NEW ELEMENTARY SCHOOL
9801 HIGHLAND KNOLLS DR
BAKERSFIELD
CALIFORNIA 93306

NEW MIDDLE SCHOOL
4115 WINELAND ROAD
BAKERSFIELD
CALIFORNIA 93306

THE DRAWINGS, IDEAS, AND DESIGNS REPRESENTED ON THIS SHEET ARE THE PROPERTY OF THE ARCHITECT.
COPYRIGHT © ORDIZ-MELBY ARCHITECTS, INC. 2010
SHEET TITLE
LIGHTING PLAN BUILDING A

SHEET IDENTIFICATION NUMBER
E-132A
SHEET OF

SWITCHBANK DETAIL

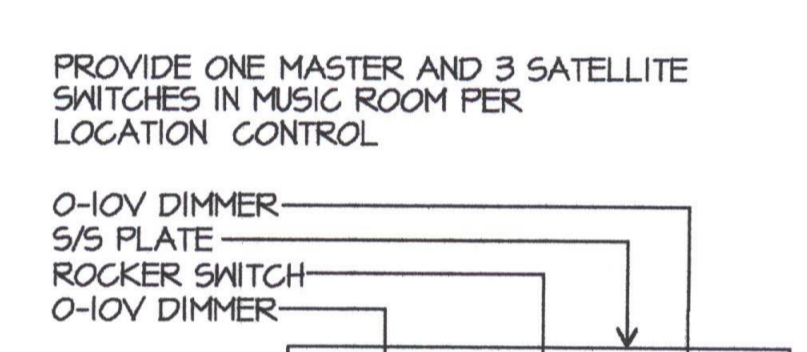
RFI 181
REQUEST: RDM Electric - 10/19/12
Reference Sheet E-132A
The Electrical Plans for Building A show a Plan Note #6 in Room A110. Plan Note #6 refers to the installation of a Lutron Grafik Eye Panel. However, there is no panel symbol shown in Room A110. Is there in Room A113. Does Room A110 require a Lutron Grafik Eye Panel? Please advise.
ANSWER: John Maloney - JMPE - 10/29/12
Room A114 is controlled by switch banks detailed in A/E132A.
Room A110 is controlled by a motion sensor. There is no grafik eye here.

LIGHTING PLAN BUILDING A

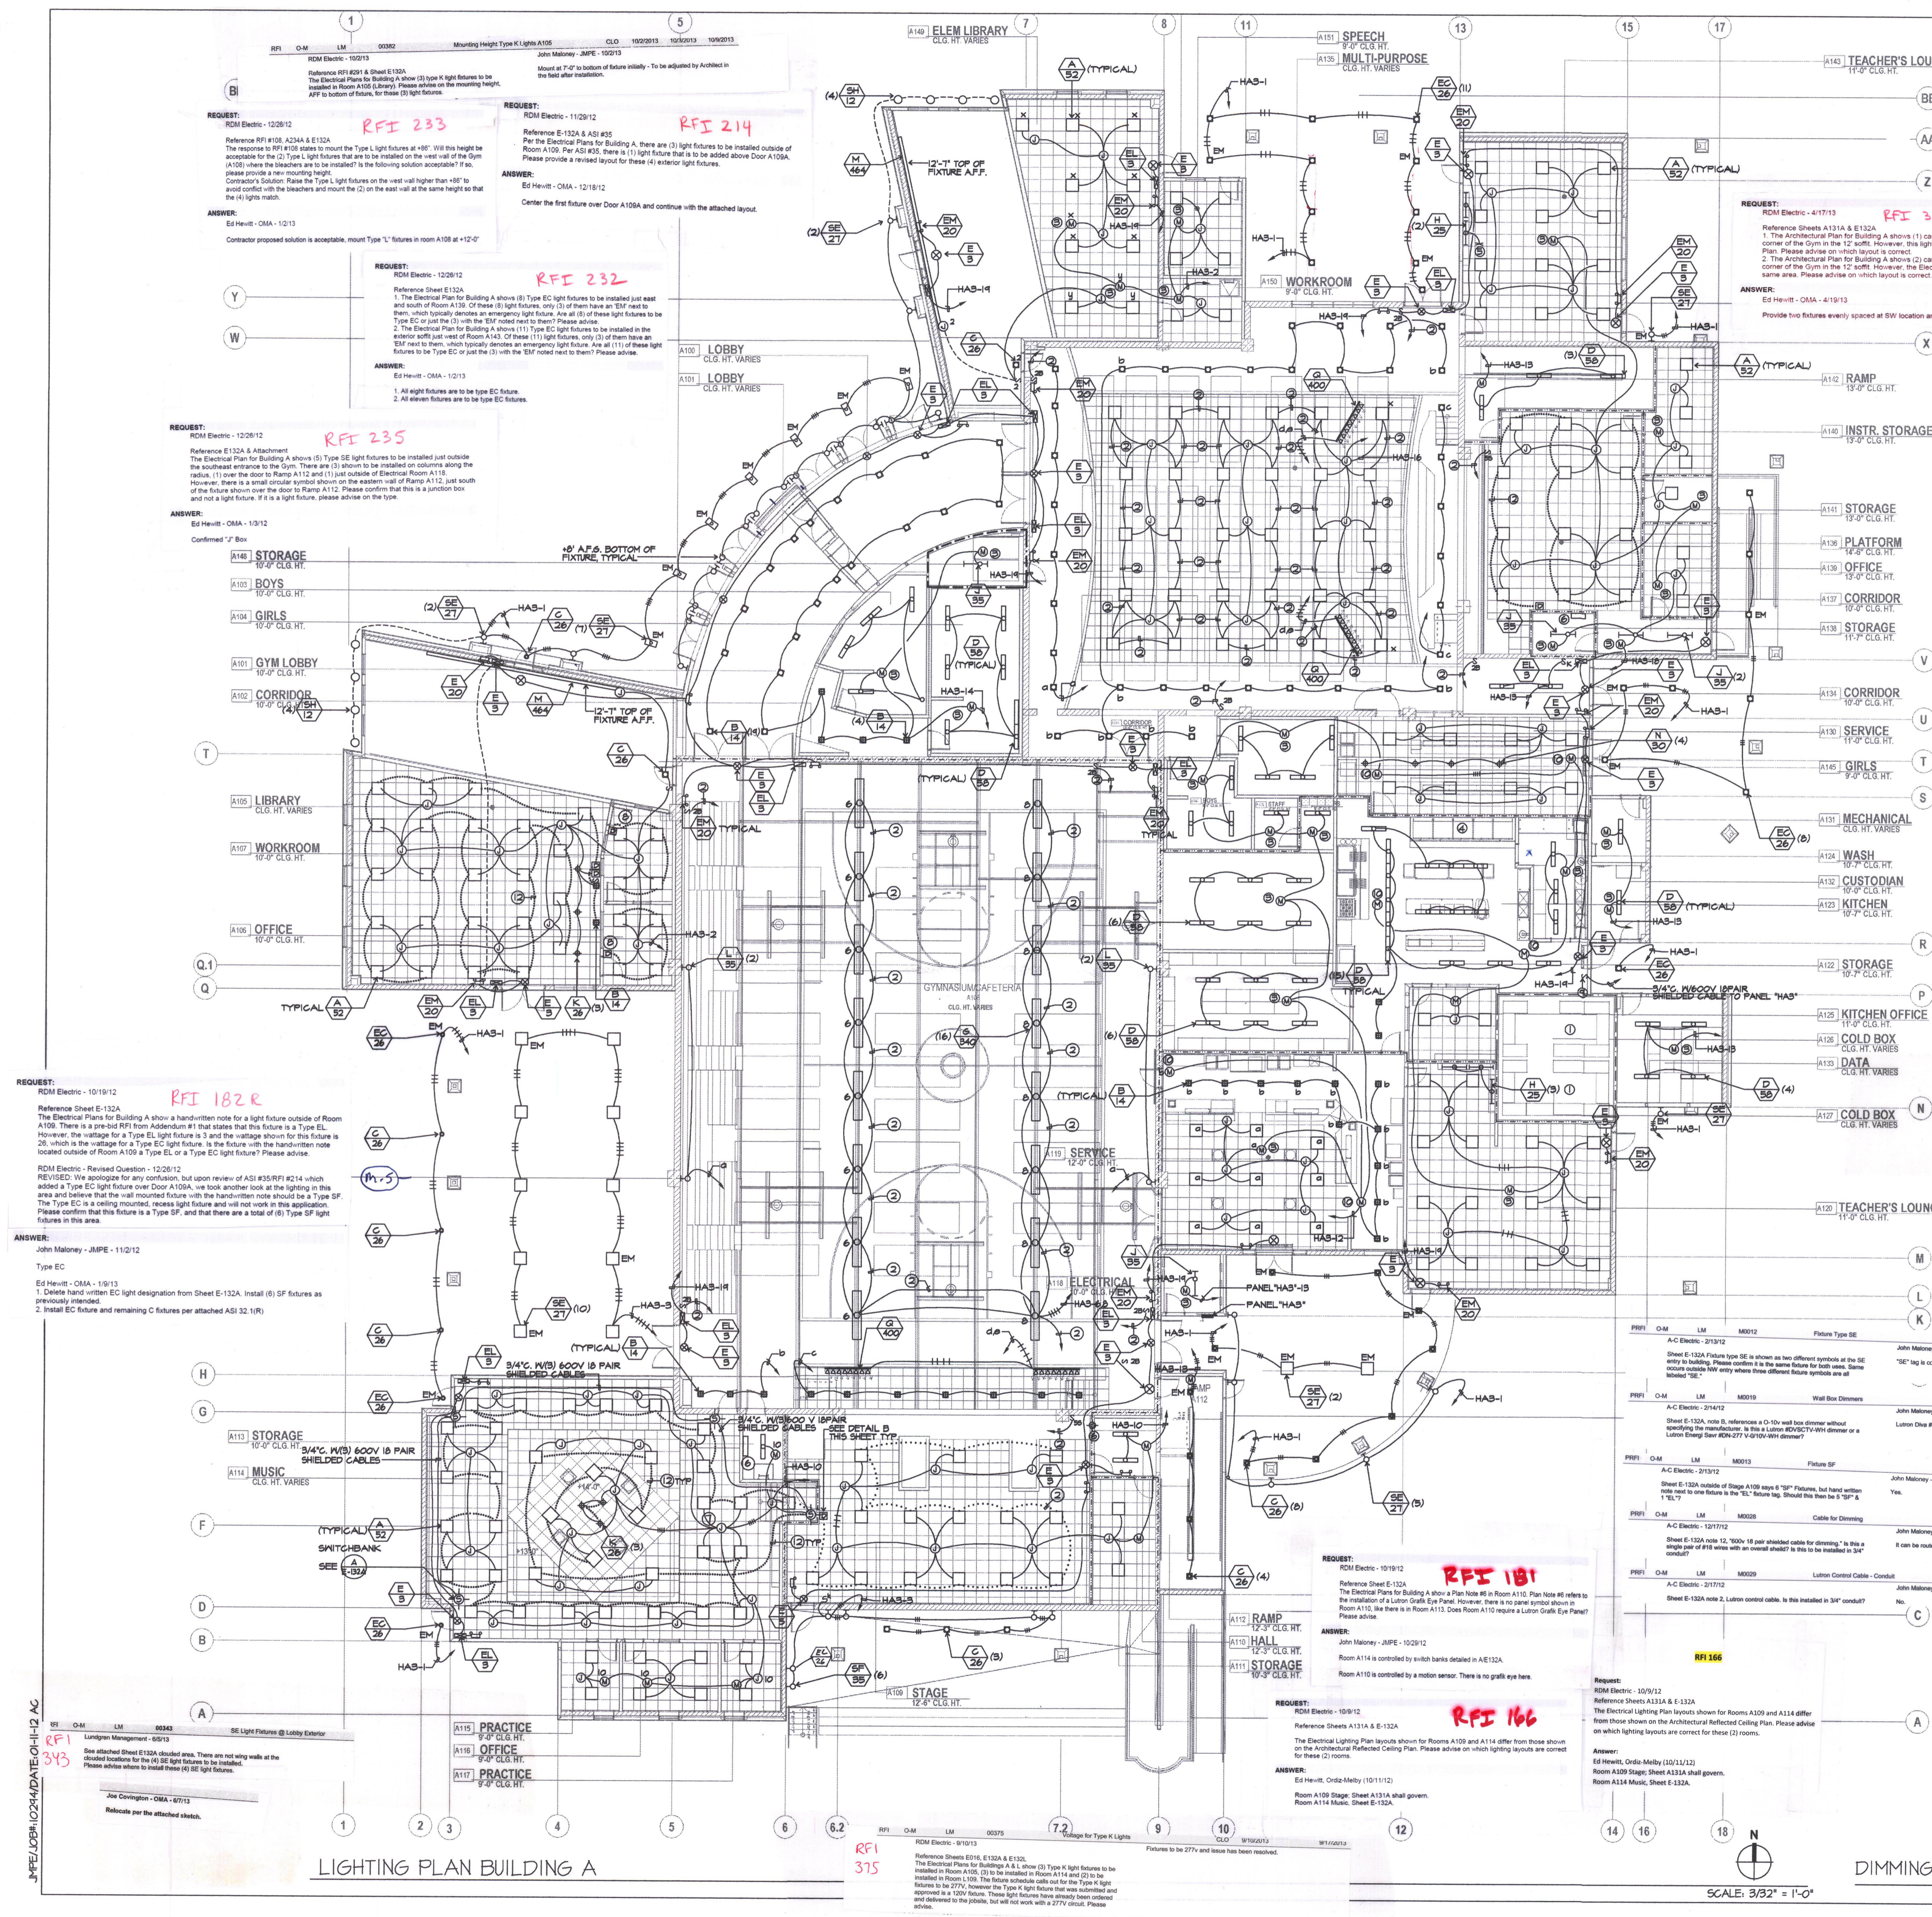
RFI 182
REQUEST: RDM Electric - 10/19/12
Reference Sheet E-132A
The Electrical Plans for Building A show a handwritten note for a light fixture outside of Room A109. There is a pre-issued RFI from Addendum #1 that states that this fixture is a Type EL. However, the voltage for a Type EL light fixture is 3 and the voltage shown on the fixture is located outside of Room A109 a Type EL or a Type EC light fixture? Please advise.
ANSWER: John Maloney - JMPE - 11/2/12
Type EC

RFI 233
REQUEST: RDM Electric - 12/26/12
Reference RFI #08, A23AA & E132A
The response to RFI #08 states to mount the Type I light fixtures at 48". Will this height be acceptable for the (2) Type I light fixtures that are to be installed on the west wall of the Gym A109 where the bleachers are to be installed? In the following solution acceptable? In please provide a new mounting height.
CONSTRAINTS: Light fixtures on the west wall higher than 48" to avoid conflict with the bleachers and mount the (2) on the east wall at the same height so that the (4) lights match.
ANSWER: Ed Hewitt - OMA - 1/3/13
Contractor proposed solution is acceptable, mount Type "I" fixtures in room A109 at 42".

RFI 232
REQUEST: RDM Electric - 12/26/12
Reference Sheet E132A
1. The Electrical Plan for Building A shows (8) Type EC light fixtures to be installed just east and south of Room A130. Of these (8) light fixtures, only (3) of them have an "EM" next to them, which typically denotes an emergency light fixture. Are all (8) of these light fixtures to be Type EC or just the (3) with the "EM" noted next to them? Please advise.

2. The Electrical Plan for Building A shows (11) Type EC light fixtures to be installed in the exterior soffits just west of Room A143. Of these (11) light fixtures, only (3) of them have an "EM" next to them, which typically denotes an emergency light fixture. Are all (11) of these light fixtures to be Type EC or just the (3) with the "EM" noted next to them? Please advise.

RFI 235
REQUEST: RDM Electric - 12/26/12
Reference E132A & Addendum
The Electrical Plan for Building A shows (5) Type SF light fixtures to be installed just outside the southeast entrance to the Gym. There are (3) shown to be installed on columns along the radius, (1) over the door to Rm A112 and (1) just outside of Electrical Room A118. However, there is a small circular symbol shown on the eastern wall of Rm A112, just south of the fixture shown over the door to Rm A112. Please confirm that this is a junction box and not a light fixture. If it is a light fixture, please advise on the type.
ANSWER: Ed Hewitt - OMA - 1/3/12
Confirmed "J" Box

RFI 182 R
REQUEST: RDM Electric - 10/19/12
Reference Sheet E-132A
The Electrical Plans for Building A show a handwritten note for a light fixture outside of Room A109. There is a pre-issued RFI from Addendum #1 that states that this fixture is a Type EL. However, the voltage for a Type EL light fixture is 3 and the voltage shown on the fixture is 26, which is the voltage for a Type EC light fixture. Is the fixture with the handwritten note located outside of Room A109 a Type EL or a Type EC light fixture? Please advise.
RDM Electric - Revised Question - 12/26/12
REVISED: We apologize for any confusion, but upon review of ASI#35RFI#214 which added a Type EC light fixture over Door A109A, we took another look at the lighting in this area and believe that the wall mounted fixture with the handwritten note should be a Type SF. The Type EC is a ceiling mounted, recess light fixture and will not work in this application. Please confirm that this fixture is a Type SF, and that there are a total of (6) Type SF light fixtures in this area.

RFI 166
REQUEST: RDM Electric - 10/9/12
Reference Sheets A131A & E-132A
The Electrical Lighting Plan layouts shown for Rooms A109 and A114 differ from those shown on the Architectural Reflected Ceiling Plan. Please advise on which lighting layouts are correct for these (2) rooms.
ANSWER: Ed Hewitt, Ordiz-Melby (10/11/12)
Room A109 Stage, Sheet A131A shall govern.
Room A114 Music, Sheet E-132A.

RFI 375
Request attached Sheet E132A qualified areas. There are not any walls at the specified locations for the (4) SE light fixtures to be installed. Please advise where to install these (4) SE light fixtures.
John Covington - OMA - 6/7/13
Relocate per the attached sheets.

RFI 375
REQUEST: RDM Electric - 3/19/13
Reference Sheet E132A & E132C
The Electrical Plans for Building A show (3) Type K light fixtures to be installed in Room A109. (2) to be installed in Room A114 and (2) to be installed in Room A109. The fixture schedule calls out for the Type I light fixture to be 277V. However, the Type I light fixture that was submitted and approved is a 120V fixture. These light fixtures have already been ordered and delivered to the jobsite, but will not work with a 277V circuit. Please advise.
ANSWER: Ed Hewitt - OMA - 6/7/13
Relocate per the attached sheets.

ANSWER: Ed Hewitt - OMA - 1/3/13
1. All eight fixtures are to be Type EC fixture.
2. All eleven fixtures are to be Type EC fixtures.

ANSWER: John Maloney - JMPE - 11/2/12
Type EC
Ed Hewitt - OMA - 1/9/13
1. Delete hand written EC light designation from Sheet E-132A. Install (6) SF fixtures as previously intended.

2. Install EC fixture and remaining fixtures per attached ASI 32.1(R)
